Staff Report to the Zoning Administrator

Application Number: **211316**

Site Address: 266 Cliff Ct, Aptos

Project Description: Proposal to construct an approximately 110 linear foot pin pier retaining wall, on-site with an existing single-family dwelling.

GRADING & DRAINAGE PLAN

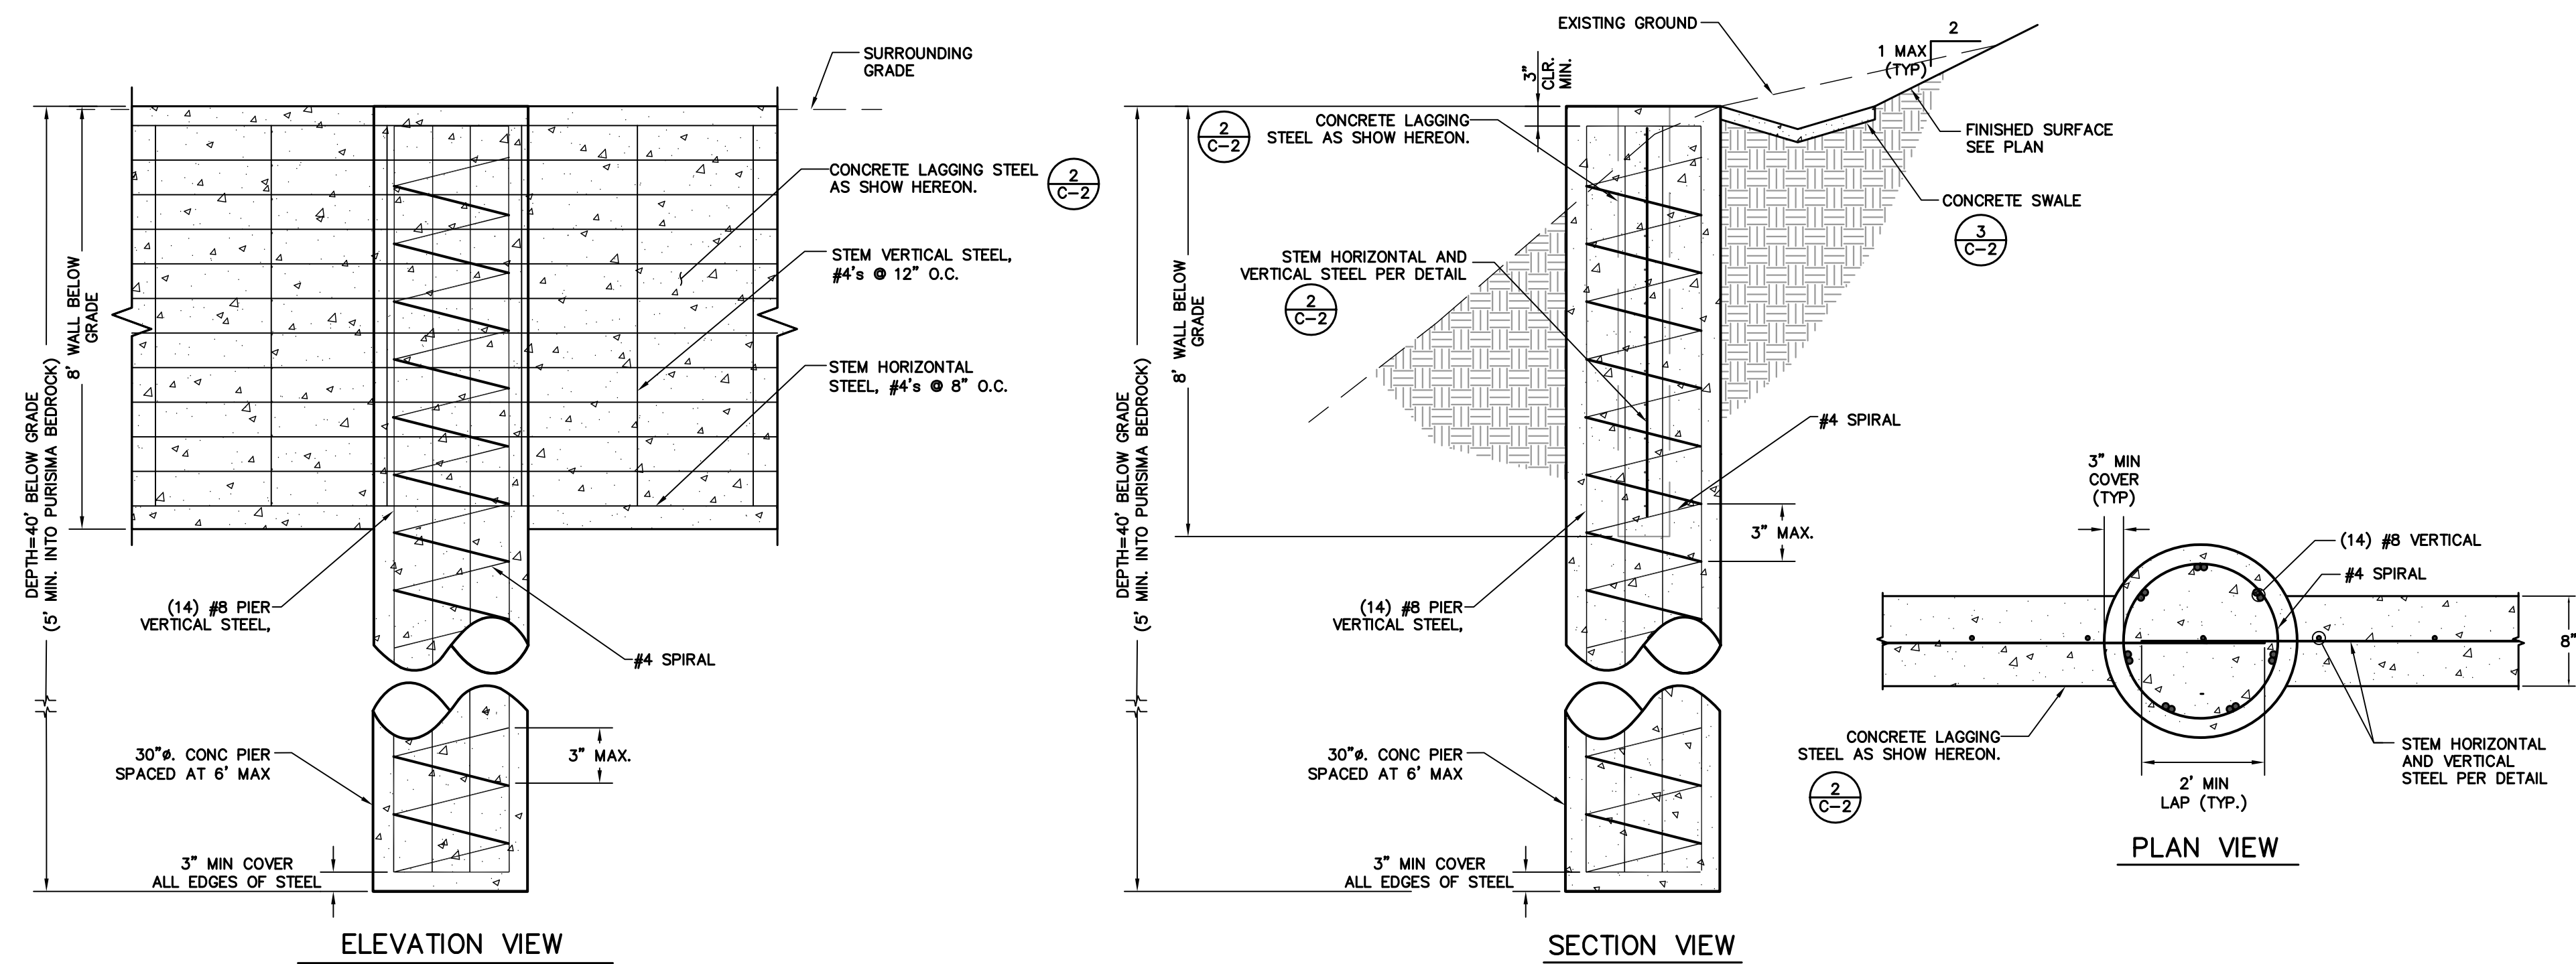
1. Provide topographic and survey information adequate for describing the current drainage facilities and patterns on and around the project site, including at a minimum the following: all existing drainage facilities on the site and which areas drain to these facilities; how existing runoff from upstream areas east of the site is currently routed through/around the project site; and the current extent of all existing drainage facilities (both on and offsite) that will be removed as part of this project and those that will remain. The note to remove and/or plug all existing pipes is insufficient. Please update the plan/s to show all existing pipes in vicinity of the southerly property identified in the photo in the geologic investigation.

2. Provide topographic information that extends at least to the inlet on the property to the west that the proposed system will tie into. Provide detailed information about the diversion path (pathway, materials, slope, ownership, etc.) from the site to the point at which the path ties into the existing downstream path, or to the beach/ocean outfall, whichever is shorter.

3. Provide existing and proposed watershed area map/s. The existing map shall show the extent of on and offsite area/s that drain to the existing drainage facilities that will be removed as part of this project. The proposed watershed map shall show the extent of the on and offsite area/s that will drain to the proposed drainage system. Provide a map that shows what existing and proposed watershed areas being proposed to drain to the diversion path.

4. Provide a signed and stamped engineer’s analysis evaluating the adequacy of the condition, stability and capacity (at least 25 year safe overflow is required) of the entire diversion path (see comment No. 2 above)— including private and public portions. Provide photo, video, and survey information used for the analysis. If any inadequacies are identified the applicant shall update the project scope to include upgrades/repairs/replacements as needed. If the diversion path terminates at Rio Del Mar Boulevard, the proposal will not be approved.

- Per Part 3 of the County Design Criteria, all development and redevelopment projects shall clearly show that proposed drainage patterns will not result in diversion of stormwater and will not adversely impact neighboring properties or drainage pathways.
 - The project design conflicts with Part 3 of the Santa Cruz County Design Criteria since diversion of stormwater is proposed and is therefore not in compliance. In order to bring the project into compliance with the County Design Criteria, the project needs to be changed so that it does not result in diversion of stormwater.
 - The County Design Criteria does allow for an exception to be considered for approval of diversion of stormwater. It states, “Diversion of runoff resulting in altered stormwater (drainage) patterns from the project site is not allowed without prior approval by the Director of Public Works.”
